City of El Paso – City Plan Commission Staff Report

Case No: SUSU14-00049 Painted Desert at Mission Ridge 2
Application Type: Major Preliminary
CPC Hearing Date: July 17, 2014
Staff Planner: Alfredo Austin, (915) 212-1604, austinaj@elpasotexas.gov
Location: West of Darrington and North of Paseo Del Este
Acreage: 39.413 acres
Rep District: N/A
Existing Use: ETJ/Vacant
Existing Zoning: ETJ
Proposed Zoning: ETJ
Nearest Park: 1 Park (4.26 acres) proposed within Painted Desert at Mission Ridge 1 Subdivision.
Nearest School: Dr. Sue Shook (PK-5) Elementary (0.25 miles)
Park Fees Required: N/A
Impact Fee Area: This property is not located in an Impact Fee Service Area.
Property Owner: State of Texas General Land Office
Applicant: Hunt Mission Ridge, LLC
Representative: CEA Group

**PAINTED DESERT AT
MISSION RIDGE 2**

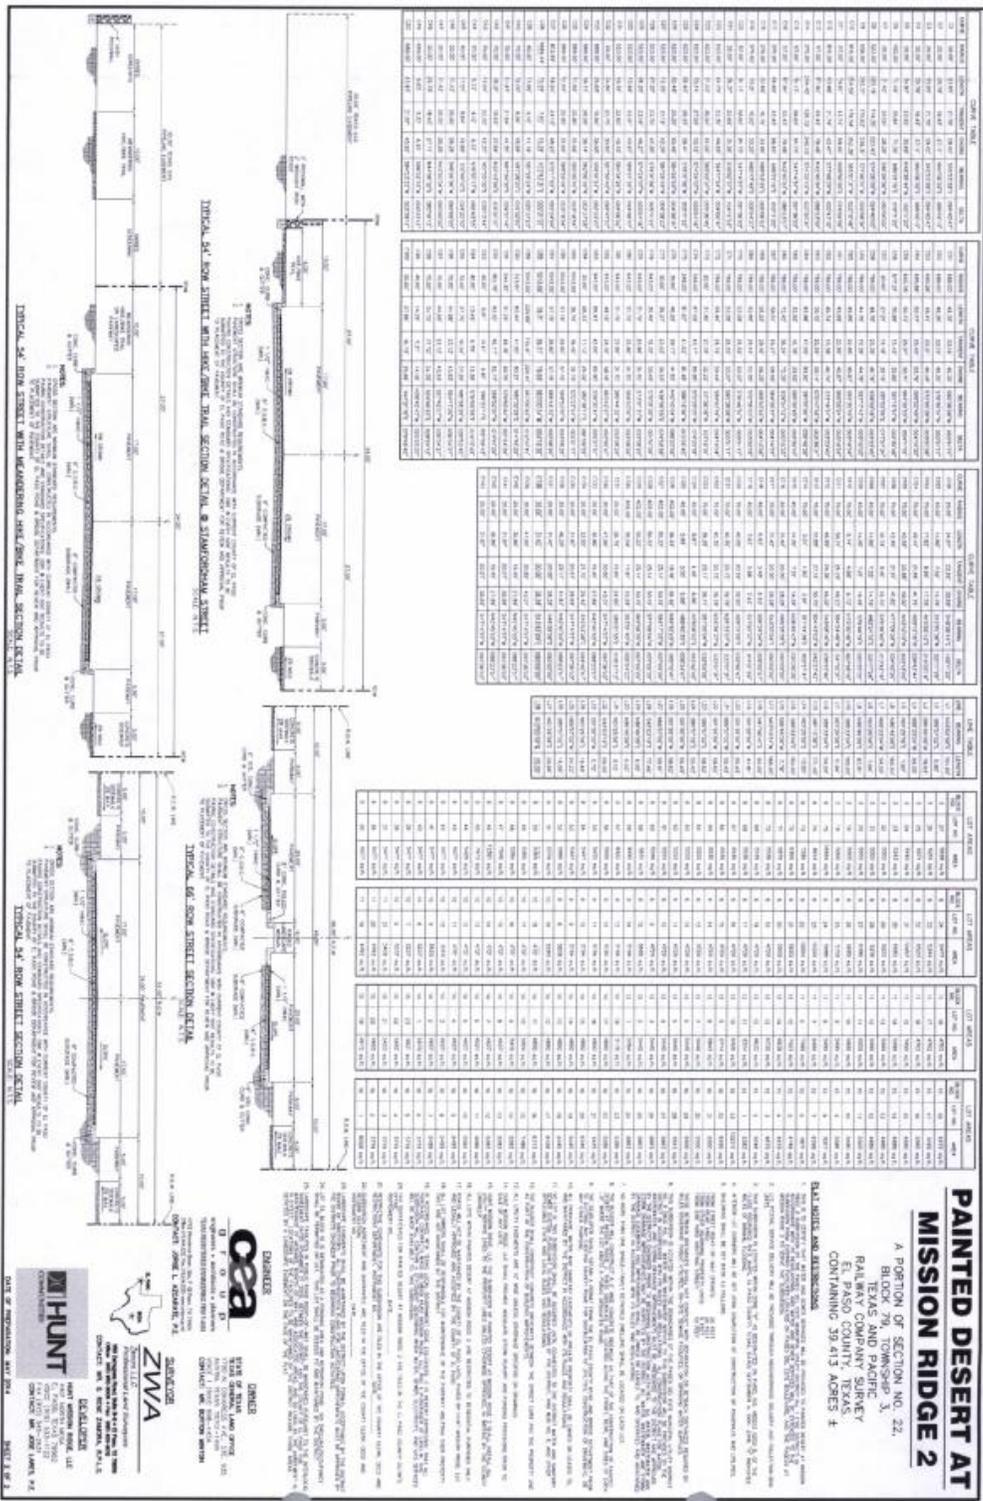
1. Provide complete Water and Sewage Facilities, and Drainage Engineering Report for ETJ requirements in English and Spanish.
2. Provide Final Engineering report notes for subdivision.
3. Label street classification on each of the typical street cross section details.
4. Retention of all storm-water runoff within the subdivision is required.
5. As per section Code 18.08.010, section D, all drainage structures and ponding areas serving the subdivision are constructed as part of the initial phase of the development.
6. Show pond maintenance access road location with proposed contours (DSC 2-3).
